Re. : Response to Office Action Mailed January 14, 2005
Appl. No. : 10/692,892
Filed : October 24, 2003

II. REMARKS

Response to Objection to the Drawings

Fig. 5

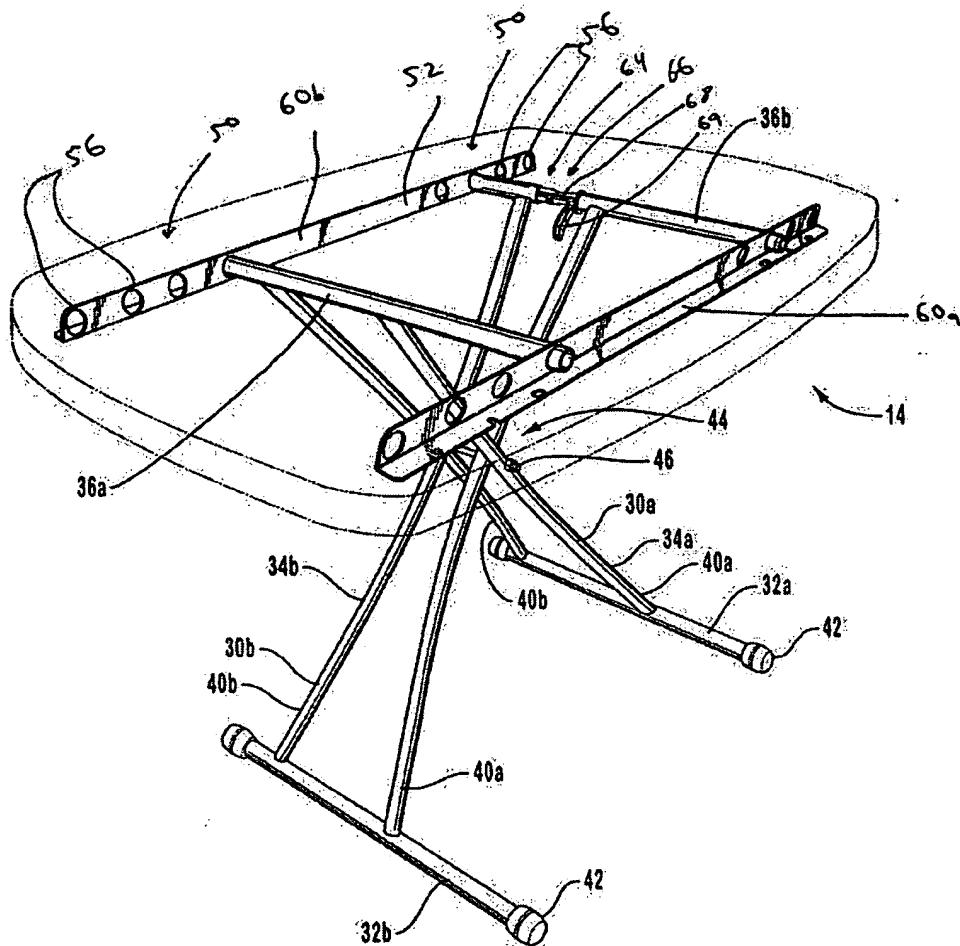
The Office Action stated that the drawings are objected to under 37 CFR 1.83(a). In particular, the Office Action stated that the drawings must show every feature of the invention specified in the claims. The Office Action stated that the limitations of Claims 14-37 showing a single support assembly must be shown or the feature(s) canceled from the claim(s).

Figures 5-9 of the drawings, as discussed in the specification, show an exemplary embodiment of a single support assembly with a first leg and a second leg. In particular, Figure 5 shows the support assembly 14 with the first leg 30a and the second leg 30b.

Therefore, Figure 5 discloses an exemplary embodiment of a single support assembly. Accordingly, the drawings show every feature of the invention specified in the claims. Therefore, Applicants request that this objection to the drawings be withdrawn.
